EC 360234
EVALUATION

This EC (360234) evaluates the acceptability of discharging tritiated water from the Exelon pond, using the Interim Remedial Action Pumping System (IRAPS), pumping the tritiated water into the Circulating Water System Blowdown Line (CW BDL) and discharging it to the Kankakee River. The EC provides a description of new and existing components, revisions to existing systems and components and their operation and control. Additionally, the EC provides the basis and the methods that will be employed to ensure the plan is acceptable with regards to licensing and regulatory requirements.

CIRCULATING WATER BLOWDOWN LINE-ØCW09C-48"
 VACUUM BREAKER #2 VAULT
 EC 360234 REV. 000
 ALTERNATE CONNECTION FOR POND DISCHARGE

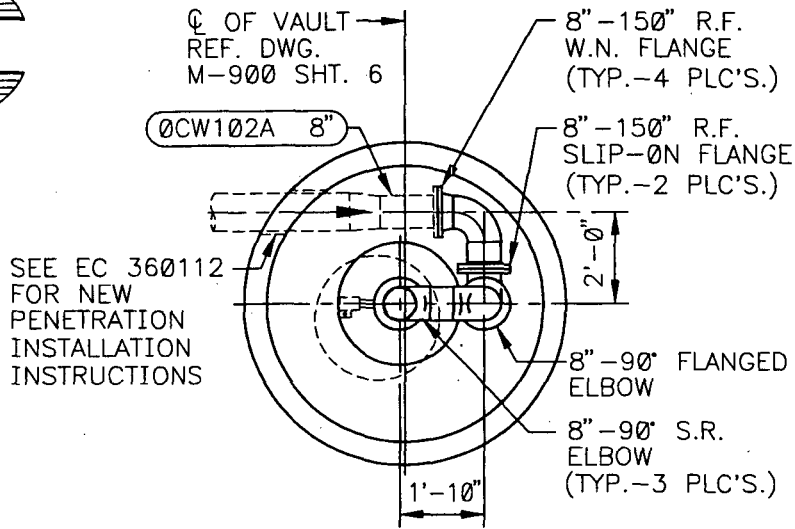
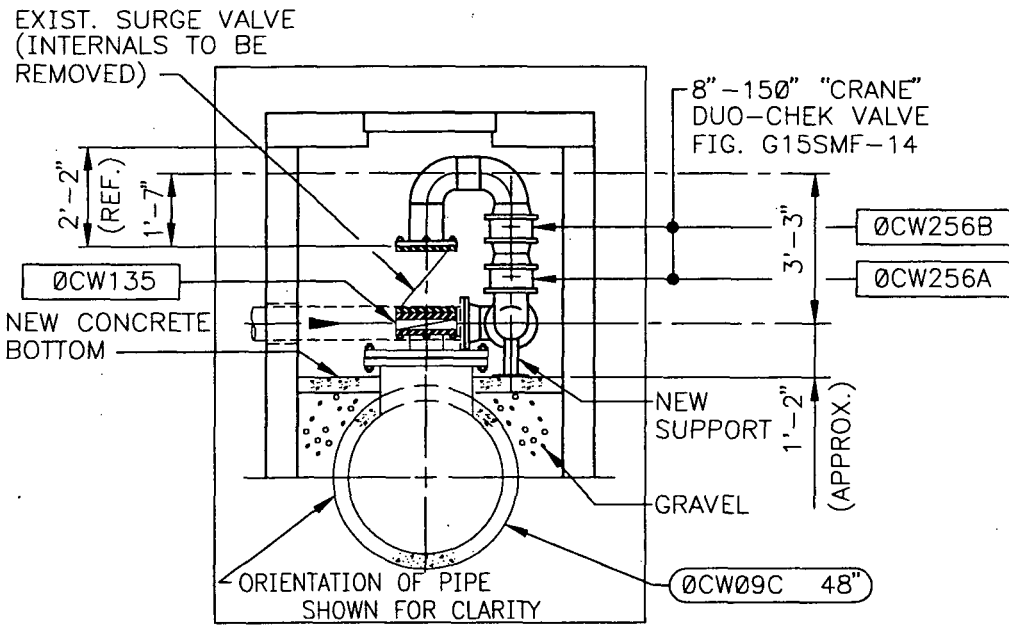
↑ IS this method #1
